PIK/L3165-1/cam

19 November 2013

RE: FRANKLIN KAAWA AQUIFER GROUNDWATER AVAILABILITY REVIEW**1. Background**

Figure 3.6 Kaawa aquifer groundwater levels

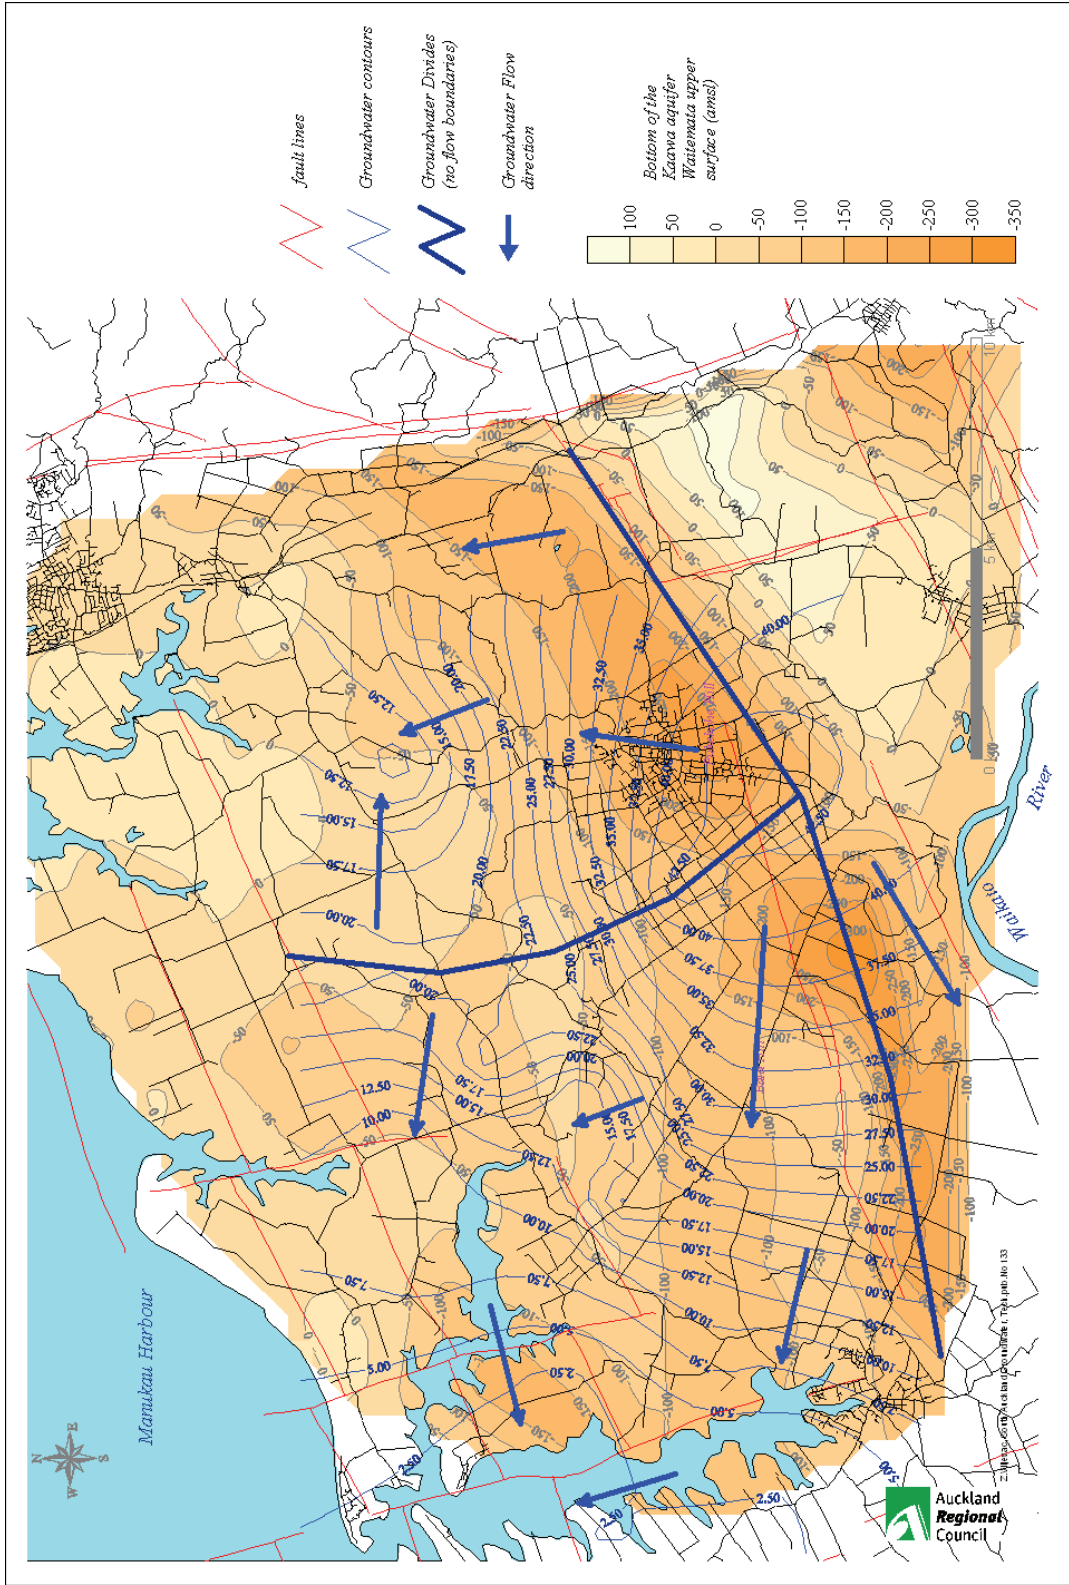
The Kaawa aquifer groundwater flowpaths are shown on Figure 3.6 of TP133. This figure is attached in Appendix B. Three of the six existing management areas (Karaka, Waiau Pa-Glenbrook and Waiuku) are located in down gradient zones of particular flowpaths. Setting availabilities in these down gradient areas without considering flow over the total flowpath length can result in unnecessary restrictions to local availability. Hence a reduction in management areas from six to four is recommended so that each new management area extends over a particular groundwater flowpath.

TP133 (Cross Sections 5-5' and 6-6', presented on TP133 Figure 2.5) shows the Kaawa aquifer extending to the north of the management zones in the Kingseat area. Associated groundwater availability has not been assessed by TP133 due to the limited northern extent of the Kaawa flownet (see Figure 3.6 – Appendix B). The Table 4.1 calculated availabilities exclude the Kaawa aquifer in the Kingseat area.

For future Kingseat Kaawa takes, groundwater availability needs to be assessed. On the basis of the Figure 3.6 flownet presented in TP133, associated recharge in this area is expected to be primarily from vertical leakage through the overlying Puketoka Formation.
